PART AFFECTED: TP164386 Magnet Mounting Bracket

REASON: To prevent first character garble due to armature sticking to pole pieces on the selector magnet assembly.

CHANGE: The manufacturing process for the TP164386 magnet mounting bracket is revised to eliminate the substance that causes the armature to hang up.

TP164386 MAGNET MOUNTING BRACKET

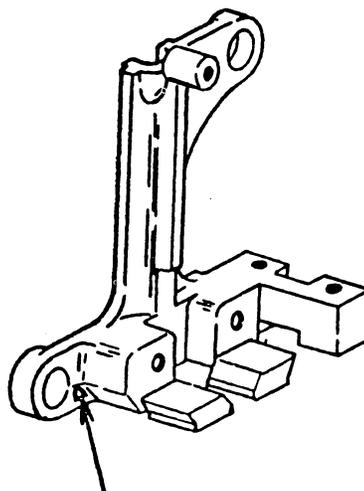
IDENTIFICATION: The TP164386 magnet mounting brackets manufactured by the revised process can be identified by the presence of a blue dot near the lower mounting hole. See Attachment Sheet 1.

BLUE DOT IN THIS AREA INDICATES
TP164386 MAGNET MOUNTING BRACKET
MANUFACTURED BY THE REVISED PROCESS.
